Lower Thames Crossing

5.4.1.1 Final Agreed Statement of Common Ground between (1) National Highways and (2) the Environment Agency (Tracked changes version)

DATE: December, 2023
DEADLINE: 9A

Planning Inspectorate Scheme Ref: TR010032
Application Document Ref: TR010032/APP/5.4.1.1

Plate 1: Proposed location of HRA and ecology mitigation

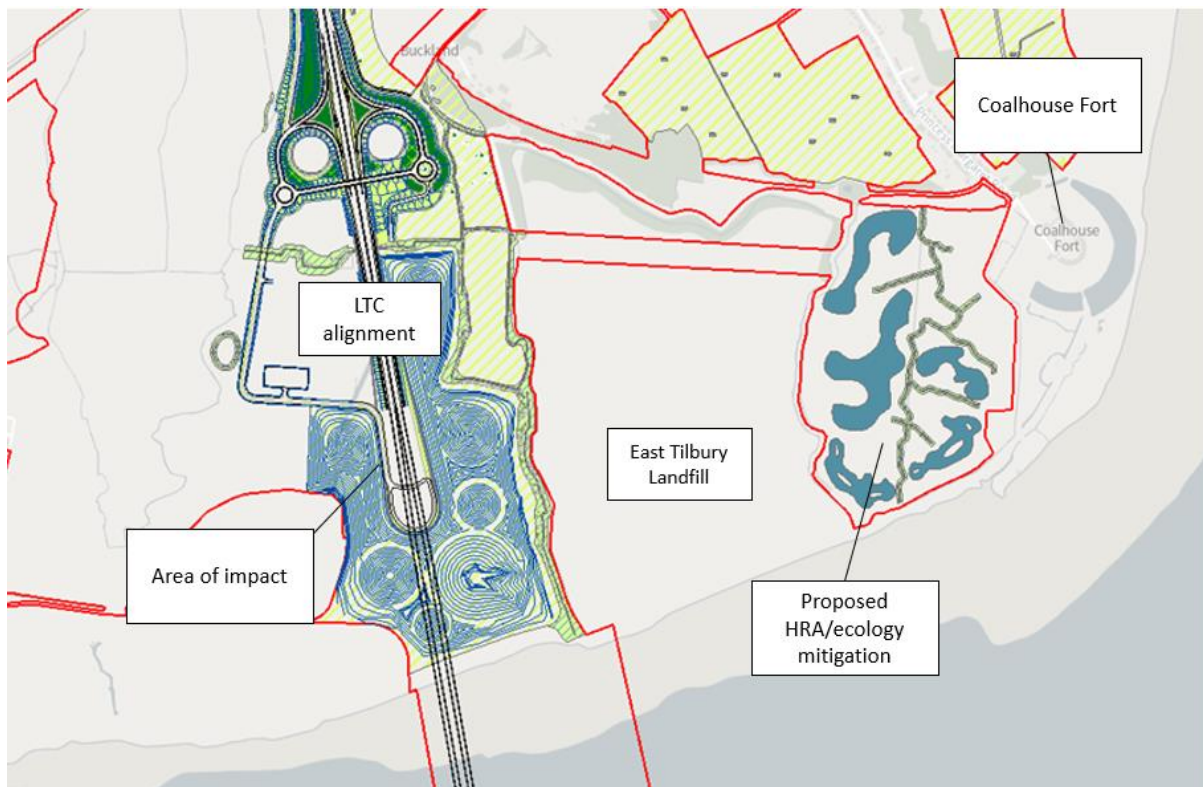
LTC's proposed Habitats Regulations Assessment (HRA) and invertebrate mitigation at Coalhouse Point requires a secure water supply. Hydrology studies indicate there is insufficient water in the natural catchment to sustain the water demand. Plate 1 presents the location and indicative design of the proposed mitigation area in the context of the LTC alignment.

- The HRA and EIA require evidence that proposed mitigation is feasible. Natural England have advised that feasibility of the mitigation will need to be presented before they would be able to agree the sufficiency of the mitigation in the SoCG, which is a DCO acceptance risk and DCO consenting risk.

Plate 2: Proposed amendments to the DCO Order Limits to provide the 50mx20-35m working space for the construction of the sluice structure. Approximate amendments to Order Limits to incorporate flood defence also highlighted.

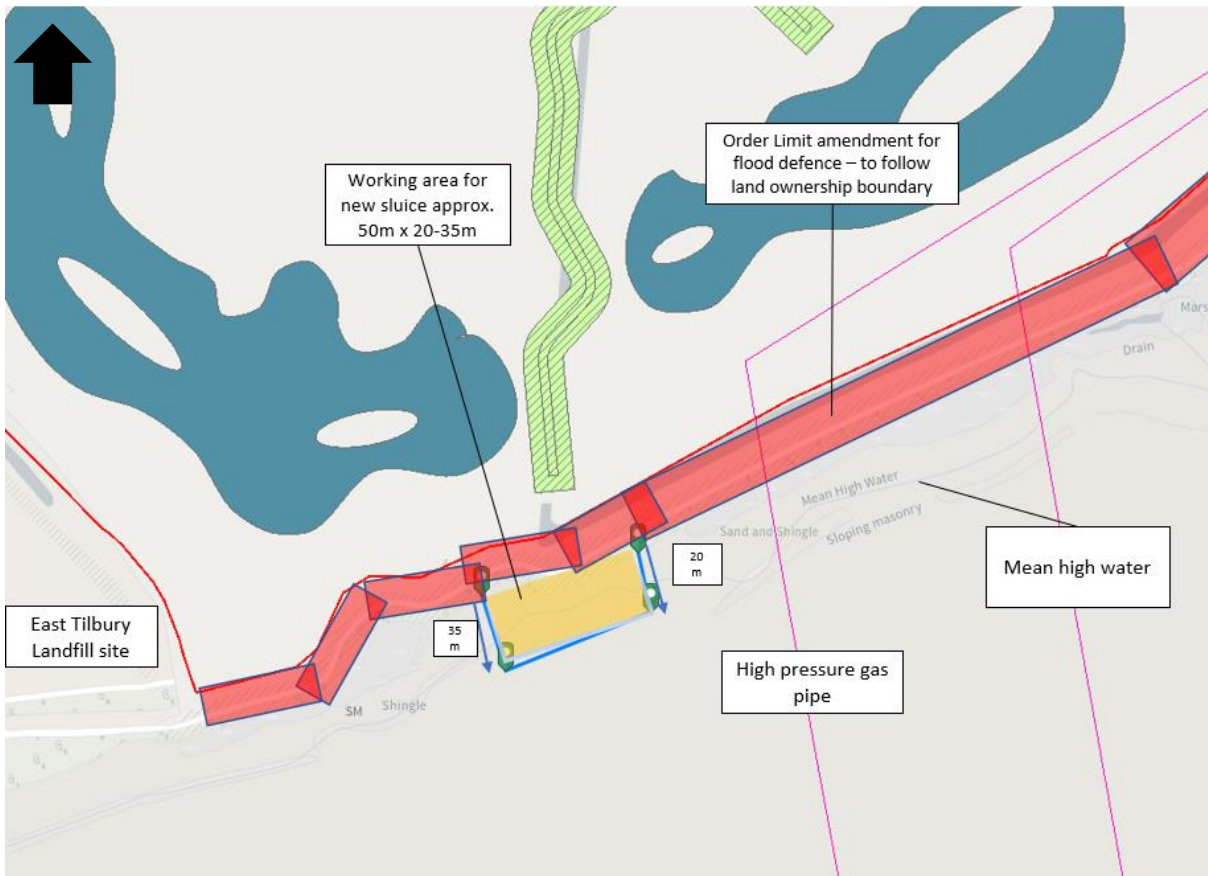
It was proposed to amend the Order Limits to incorporate the existing flood defence that is currently owned by the landowner, Mr Mott. This change was proposed irrespective of the requirement of a structure and is shown as the red area in Plate 2. Given the new structure would be limited to the footprint of the flood defence, this change would also incorporate the new structure.

Figure 1: Impact of increased defence levels on breach start and end times at Mardyke Sluice breach (based on future level for Option 1.4 in 2127)

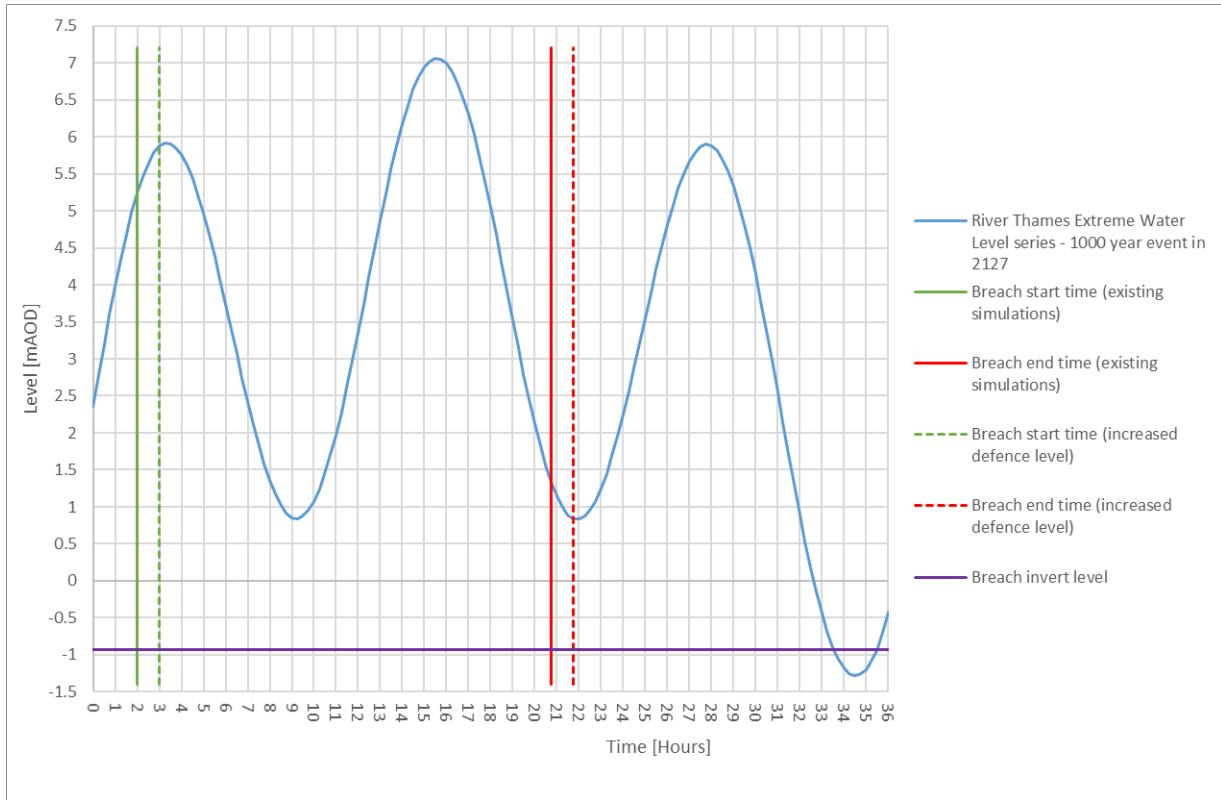
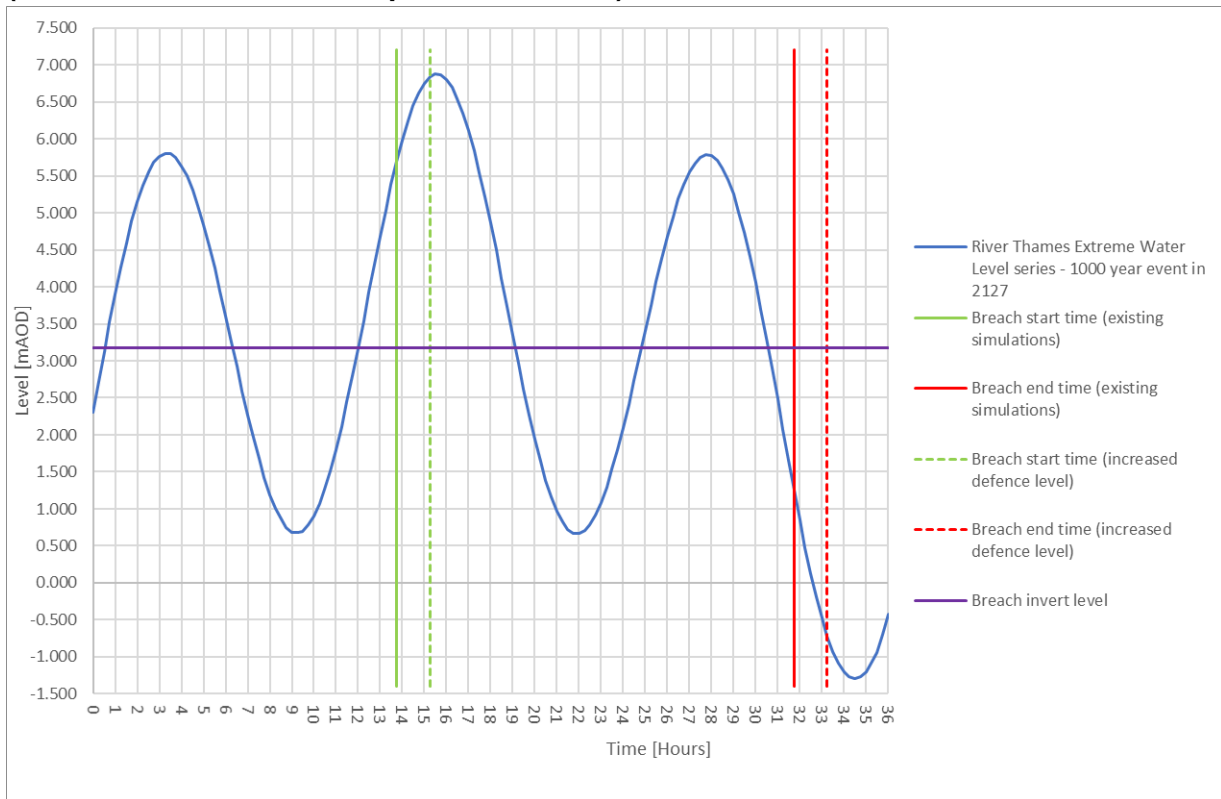
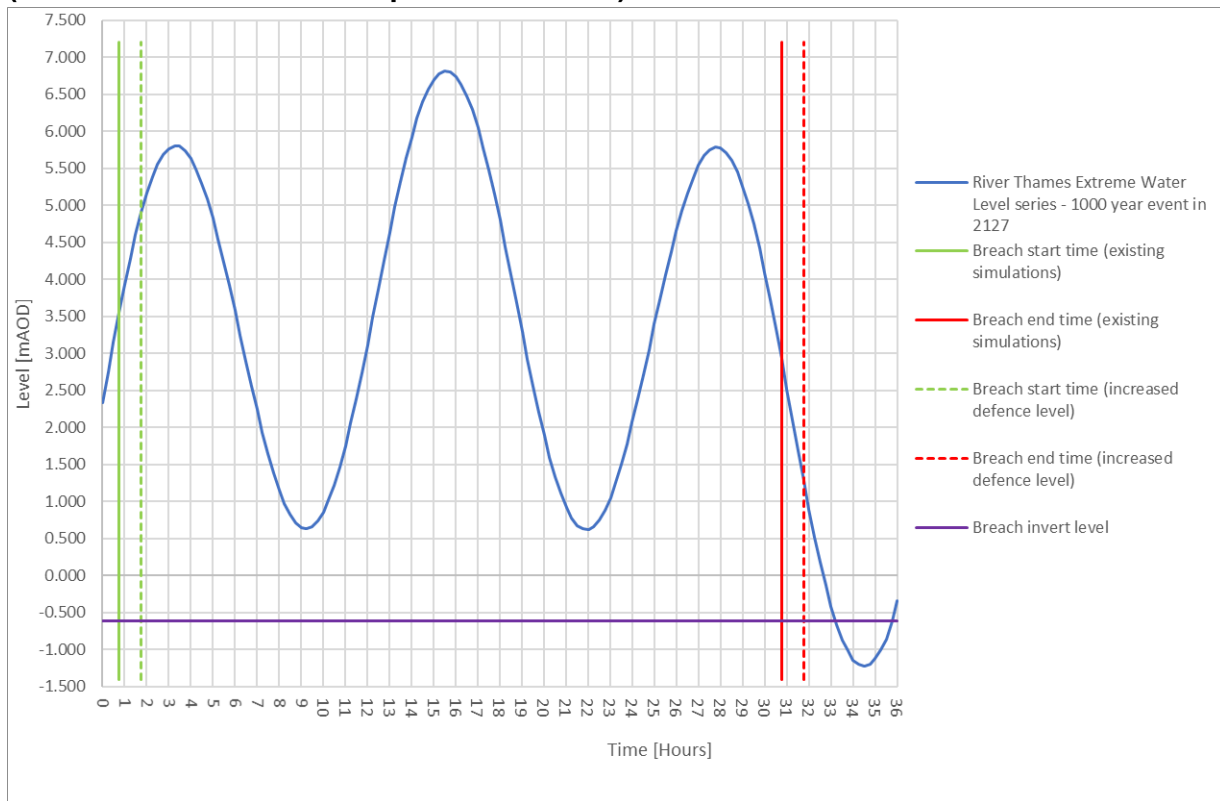
- 2.2.4 Figures 1 to 3 show the influence of increasing flood defence levels on breach start and end times for the LTC FRA breach simulations. The change in breach start and end times is shown for the highest required future defence levels (i.e. the future defence levels that are most different to those assumed in the LTC FRA breach simulations, highlighted in orange in Table 2).

2.2.5 Figures 1 to 3 show that for all LTC FRA breach locations, applying higher flood defence levels results in a delay in the start and end times of simulated breaches. An inspection of Figures 1 to 3 indicates that the reduction in initial breach flows resulting from increased defence levels (due to a delayed start) would exceed the gain in breach flows at the end of the simulated breach event, as River Thames flood levels are higher at the start of simulated breach events than at the end of the events (and for TIL005 there would be no gain in breach flows at the end of the simulated breach event, as River Thames levels would be below the TIL005 breach invert level at the end of the simulated beach). There would therefore be an overall reduction in simulated breach flood volume as a result of increasing flood defence levels.
